UNITED STATES  
NUCLEAR REGULATORY COMMISSION  
WASHINGTON, D. C. 20555

SUBJECT: FOLLOW UP ACTIONS FOR THE CALLAWAY  
INTEGRATED DESIGN INSPECTION

Facility Name: Callaway Plant, Unit 1

Det. 17, Dwg. C-0418

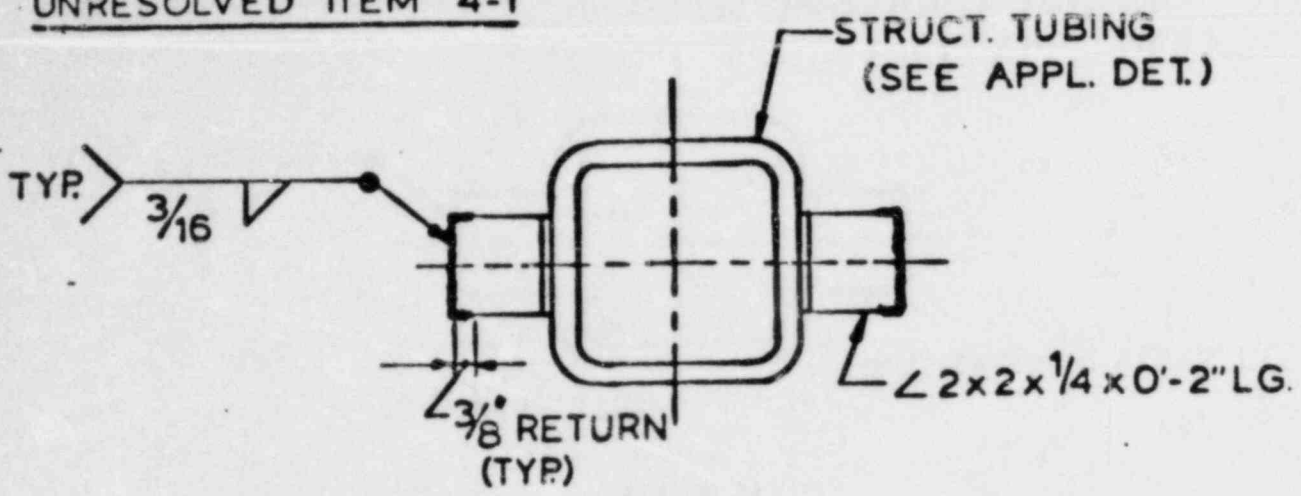
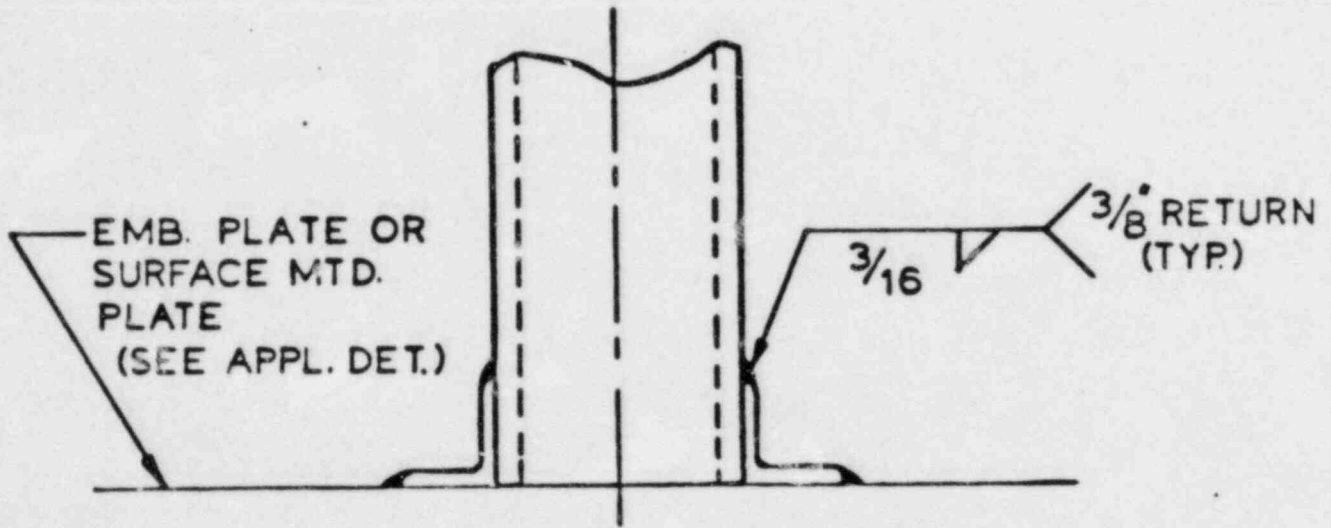
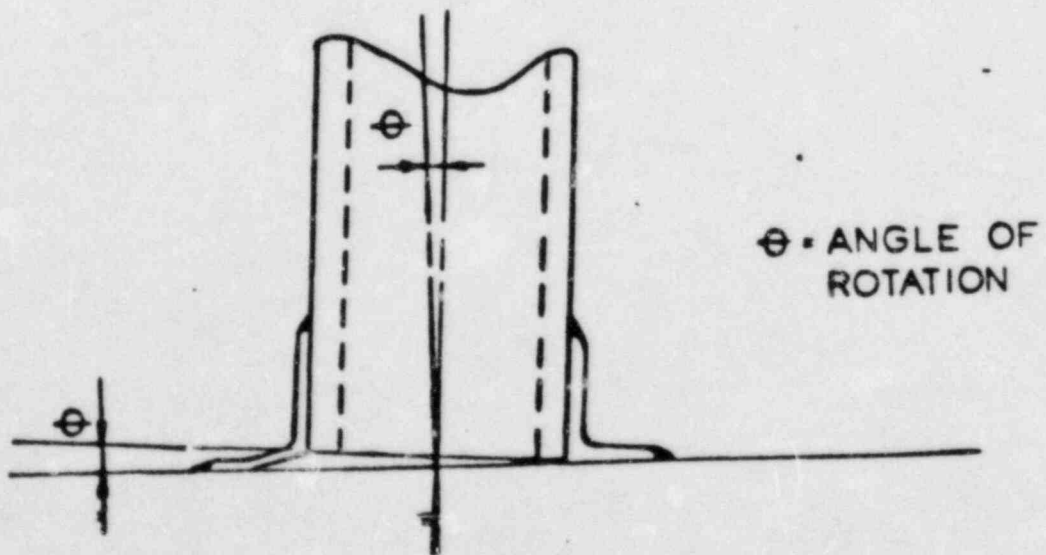
The subject connection detail was utilized in the design of cable tray supports located within the Auxiliary and Control buildings involving tubular steel members spanning between floors. The detail in question consists of two, 2" x 2" x 1/4" steel angles, two inches in length, field welded to the steel tube and a surface mounted or embedded base plate at the floor surface. The details are shown on the design drawings as follows:

The three details referenced above (see attached sketch), specify a 3/16" fillet weld to the base plate and the steel tube along the length of the angle, with a 3/8" long weld return at each end. This weld configuration allows the end of the steel tube to rotate without damaging the weld by allowing the legs of the angle to bend. This rotation can readily be developed even in the absence of a gap between the end of the tube steel and base plate. Therefore, although the connection attracts some moment when the tube is loaded in the horizontal direction (seismic loading), this moment is immediately relieved upon rotation of the joint, approaching a hinged connection. In addition, the assumption of a hinged boundary yields conservative design moments for the tube section being connected.

We therefore maintain that the assumptions made in the design of these connections are consistent with standard design practices and do not require further evaluation.
